Hi-Fi Products  
Service Bulletin

**Model:** STR-GX80ES/STR-GX90ES

**No. 211**

**Subject:** Hinges For Lid Assembly

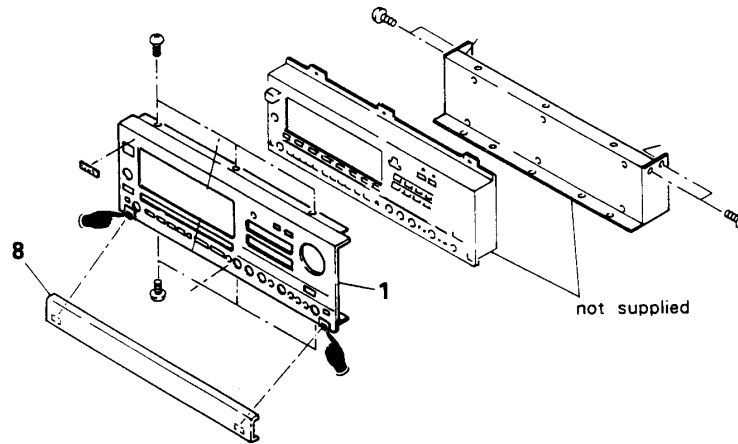
The hinges that connect the front panel assembly to the lid assembly are not listed in the Service Manual.

**Solution:** The hinges are now available:

DESCRIPTION	PART NUMBER
HINGE (R) ASSEMBLY	X-4924-921-4
HINGE (L) ASSEMBLY	X-4924-922-4
HINGE STOPPER	4-931-647-02
